QUANTITY	DESCRIPTION
1	Second Addendum to the Sub-Slab Vapor Probe Installation and Additional Site Assessment Workplan

SECOND ADDENDUM TO THE SUB-SLAB VAPOR PROBE INSTALLATION AND ADDITIONAL SITE ASSESSMENT WORKPLAN

**1137-1167 65th STREET
OAKLAND, CALIFORNIA**

AGENCY CASE NO. RO0000082

FIGURE 3 REVISED UTILITY CONDUITS AND PROPOSED SUB-SLAB
VAPOR PROBE LOCATIONS

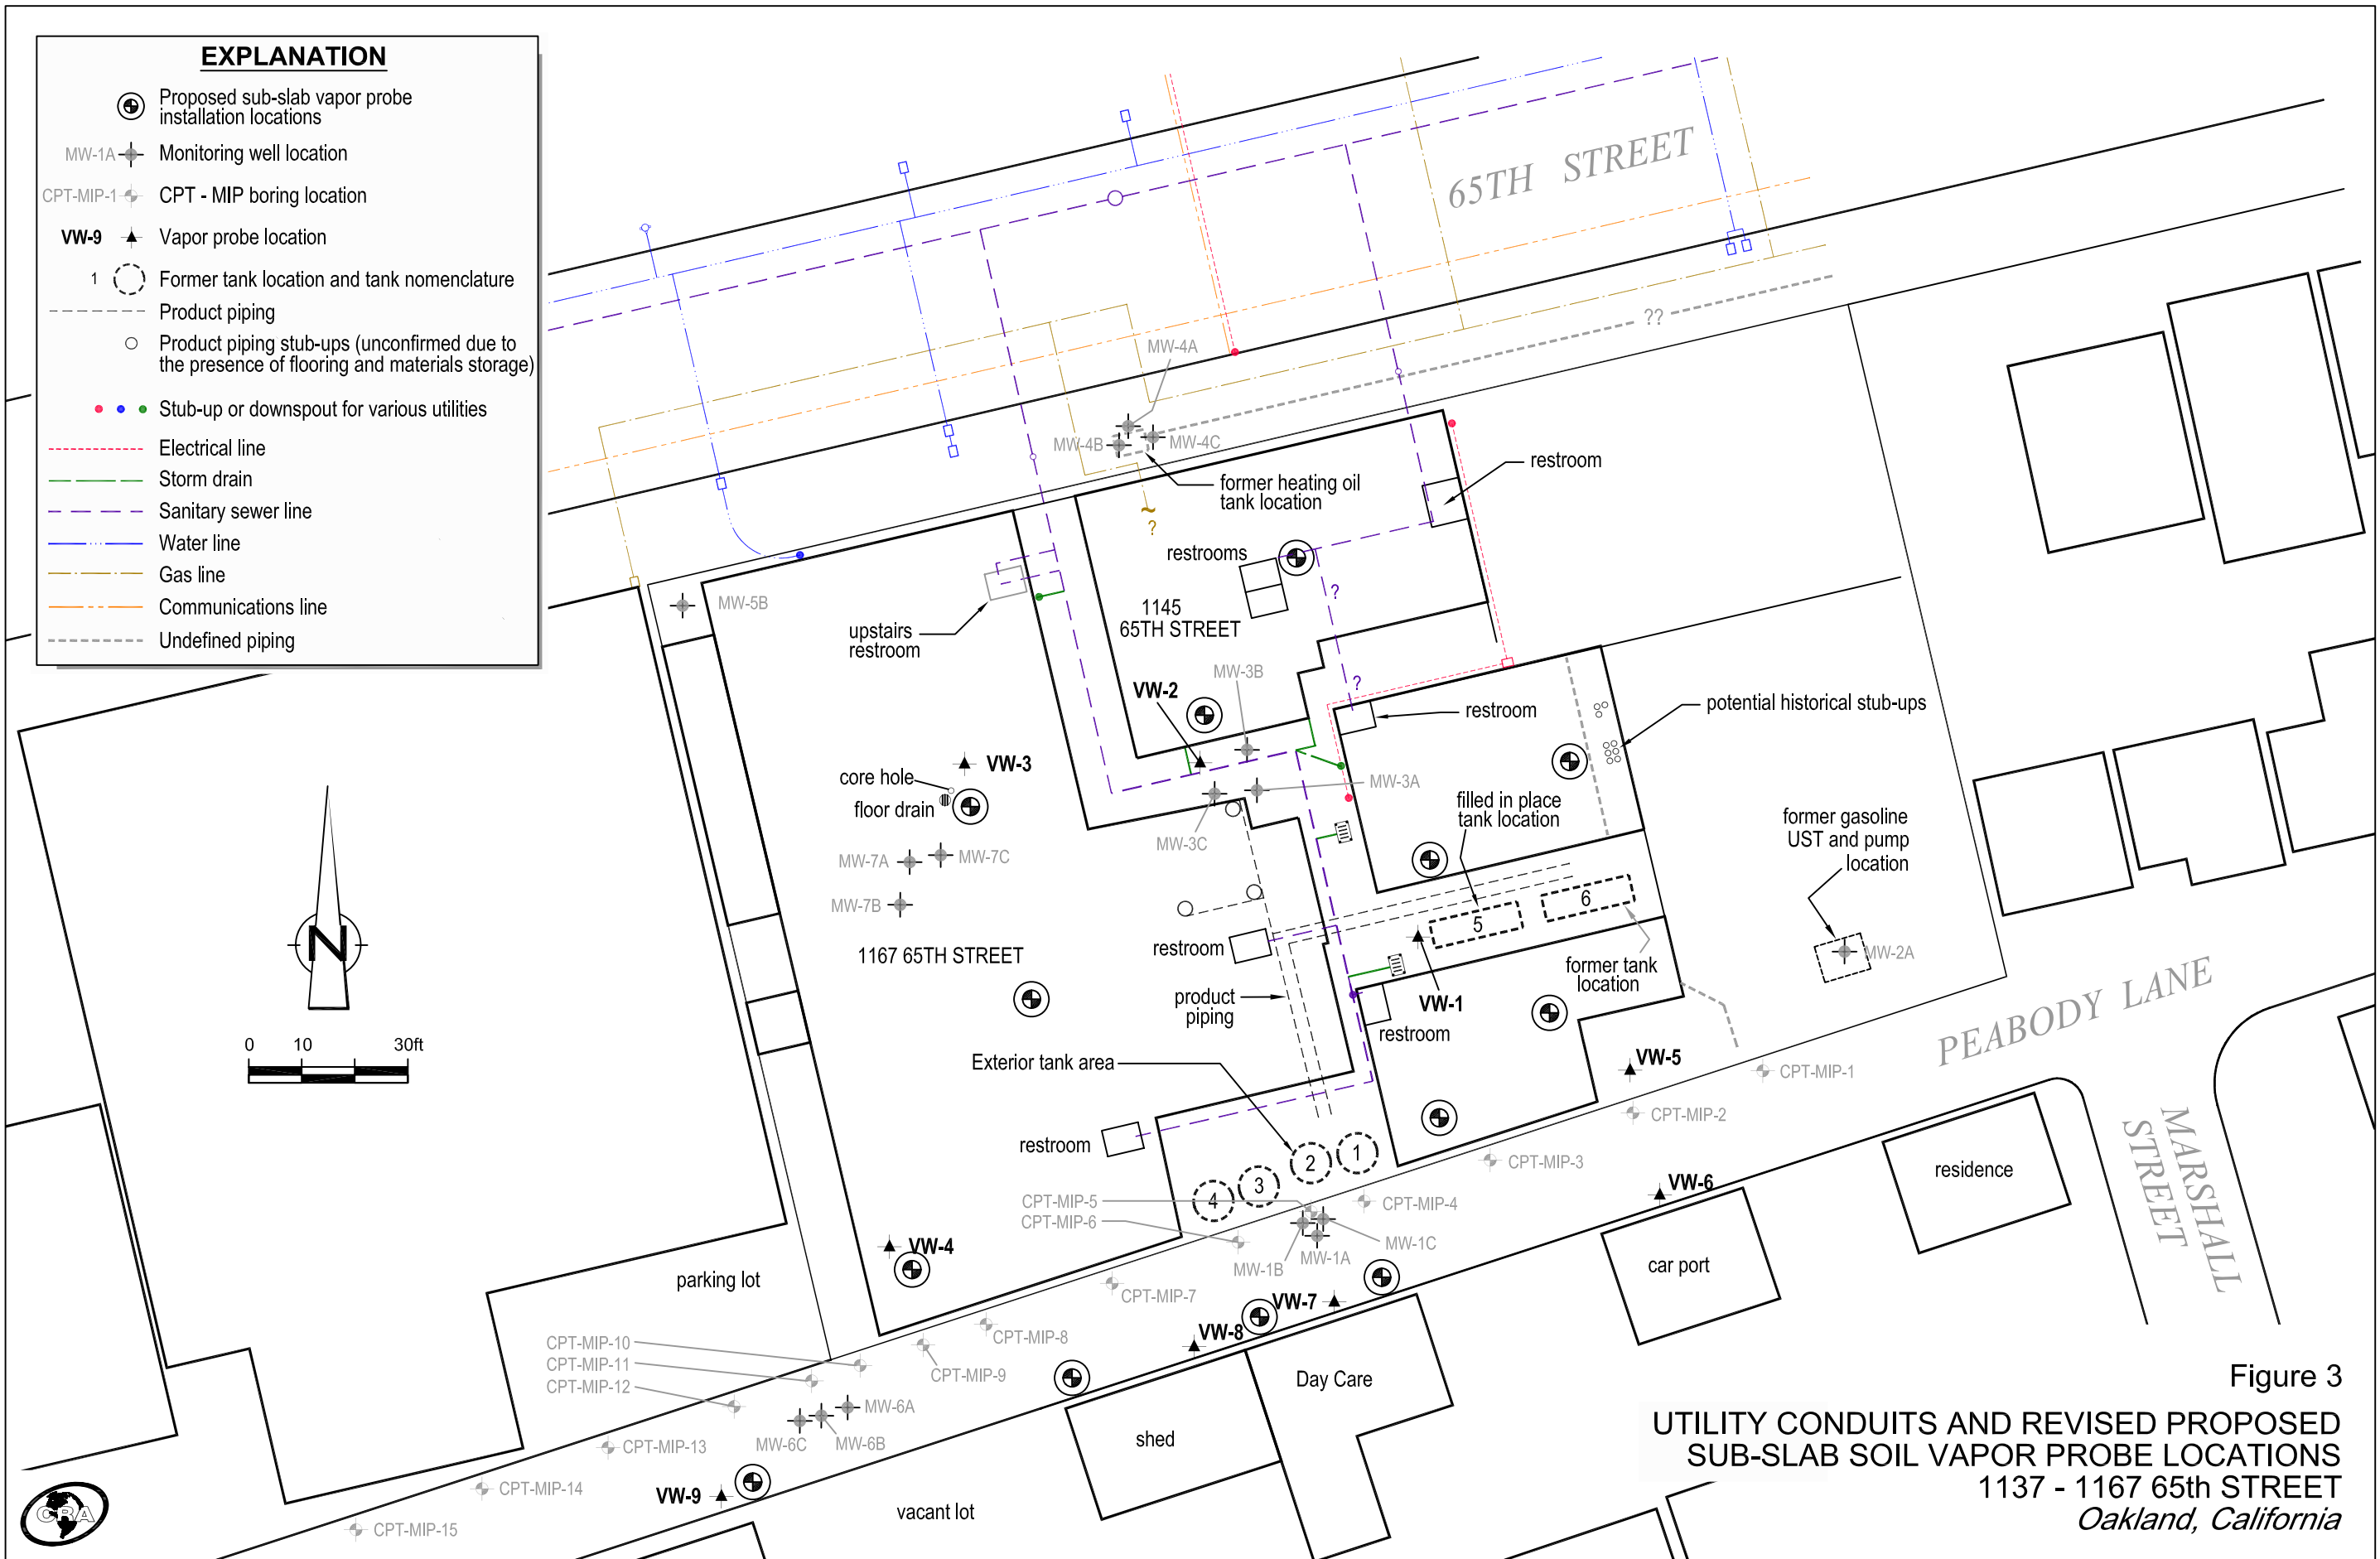
Unfortunately, it's been busy around here and we can't always meet or get to everything on the schedule. We did meet last week to discuss the site and we still have questions with the conduit maps in particular with the locations of utility laterals (in particular the sewer). Please send an updated conduit map showing the locations of the sewer laterals from the buildings to the street and any other laterals that may exist beneath the building.

According to your map the storm drain goes into the sewer lateral. This is unusual. Also, there should be restrooms at the facility somewhere. Where are the sewer lines for these? I understand that water flows to the SW but we are looking at soil vapor sampling. The location and depth could be pertinent. Also, the standard of care for a utility survey includes depths of utilities. These should also be included on the map.

The comment pertains to the path of sewer laterals leaving the site and tying into the main sewer line beneath 65th Street. From the sweep of the cleanouts previously identified in the 65th Street sidewalk, we have extended the sewer laterals to show where they should join the main line beneath the street. The direction of the cleanouts indicate that the laterals continue straight toward the main line. The attached Figure 3 illustrates the inferred path of the sewer laterals to their junctions with the main sewer line beneath 65th Street.

occurred in certain areas of Oakland and San Francisco. In fact, in San Francisco the entire storm drain and sanitary sewer system are combined into one. The attached Figure 3 has been updated to include additional storm drain lines tied into the sewer line traversing beneath the breezeway. The January 18 email also inquires about restrooms at the facility. We have surveyed the site again to locate the various restrooms and have plotted them on the revised Figure 3, as well. With the various modifications within the four buildings, such as raised floors, "temporary" walls, etc, it is difficult to detect the sewer lines from restrooms. As a result, several of the sewer line traces shown on the figure are inferred and are based on sounds emanating through sewer cleanouts when toilets were flushed within the buildings. The trace of the sewer line from the restroom in the southern end of 1167 65th St is inferred by a series of concrete cuts in the patio area bordering Peabody Lane. This patio area is identified by the location of former tanks 1 through 4.

Additionally, you will note there is an upstairs restroom in the northeastern corner of the building labeled as 1167 65th Street. Directly below that restroom, on the ground floor, is the drain line leading away from the wash trough, joined by the drain line from a wall sink and tying into the sewer/storm drain beneath the breezeway. The other sewer line indicated in this area is the line from the upstairs restroom. That line reveals itself as a 4-inch diameter metal pipe tracing vertically down through the first floor ceiling, making a 90-degree turn toward the north and disappearing into the wall. An observation of the room directly north of the wash trough does not show the trace of the pipe in that direction, and it appears that the wall in that room was constructed leaving a space where the pipe is located. There is no sewer cleanout beneath the 65th St sidewalk to indicate that the pipe traverses beneath the floor and leaves the building to the north. Without removing the constructed walls within the building, there is no way to confirm the specific path of the sewer line. However, considering the nearby sewer line beneath the breezeway and the lack of a cleanout beneath the sidewalk we presume that, behind the wall, the sewer line runs vertically down and beneath the floor, heading toward the east to tie into the sewer line beneath the breezeway.

by gravity, they must be vertically higher beneath the buildings. Considering the sloping topography and the gravity flow, it is estimated that all drain and sewer lines would be buried no deeper than four feet beneath the buildings. The former product lines are inferred to be this shallow, as well. Due to the inability to accurately determine utility depths, no estimates are made on the figure. It is noted in the explanation that all utility depths beneath the buildings are estimated to be no deeper than 4 fbg.
